ica 4 - aesthetics

January 22, 2025 11:33 AM

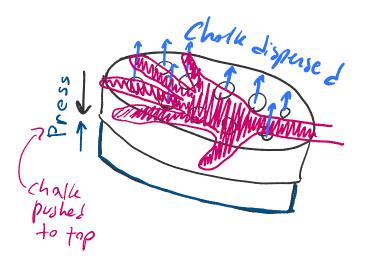
- hole pattern on top could be in a pattern that is more aesthetically pleasing rather than just a grid
- Fillets on outside edges of device
- Fillets on holes
- minimize gaps between top (white) and bottom (blue)
 - o make sure gaps are consistent
- ergonomics: maybe shape the device to a person's hand
 - o more comfortable to press your hand against
- redesign so the use is more obvious
 - o show the user that they are supposed to press down on it
 - o show the user that chalk is dispensed from the top
- use plastic as it is sufficient for this application
 - o could use metal for more premium feel
